Access Compliance Report

Public Rights-of-Way

(Curb Ramps)

Intersection ID: 10996	Main Street: E_24TH_ST	Cross Street: N_DAVIDSON_ST	Location: S
ADA ID: AE44A8666577	Ramp Type: Perp	Initial Pass/Fail: Fail	Overall Compliance: No
Severity Score: 25			
Codes/Mitigation Info/Possible Solution		Field Measurements/Component Compliance

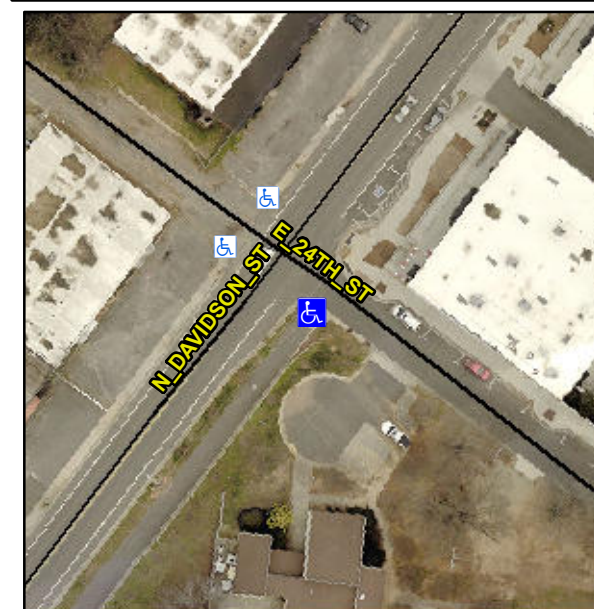
Not Found, R304.5.3

Compliance	Description	Data	Compliance	Description	Data
N/A	Ramp Length (in)	115.5	Yes	Ramp Slope (%)	6.2
Yes	Ramp Width (in)	120.0	No	Ramp XSlope (%)	13.3
N/A	Flare Type LT	N/A	N/A	Flare Type RT	N/A
N/A	Flare Slope LT (%)	N/A	N/A	Flare Slope RT (%)	N/A
N/A	Flare Traversable LT?	N/A	N/A	Flare Traversable RT?	N/A
N/A	Landing Length (in)	N/A	N/A	DWS Provided?	N/A
N/A	Landing Width (in)	N/A	N/A	DWS Contrast?	N/A
N/A	Landing Slope (%)	N/A	N/A	DWS Length (in)	N/A
N/A	Landing X Slope (%)	N/A	N/A	DWS Full Width?	N/A
N/A	Landing Curb? (Y/N)	N/A	N/A	DWS Offset (in)	N/A
N/A	Shared Landing?	N/A			
N/A	Gutter Ponding?	N/A	N/A	Gutter Slope (%)	N/A
N/A	Gutter Lip Ht (in)	N/A	N/A	Gutter X Slope (%)	N/A
N/A	Painted X Walk1?	No	N/A	Painted X Walk2?	N/A
	X Walk 1 Direction	To E		X Walk 2 Direction	N/A
N/A	X Walk 1 Width (in)	N/A	N/A	X Walk 2 Width (in)	N/A
	X Walk 1 Slope (%)	3.9		X Walk 2 Slope (%)	N/A
	X Walk 1 X Slope (%)	10.4		X Walk 2 X Slope (%)	N/A

Remove & Replace Entire Ramp.
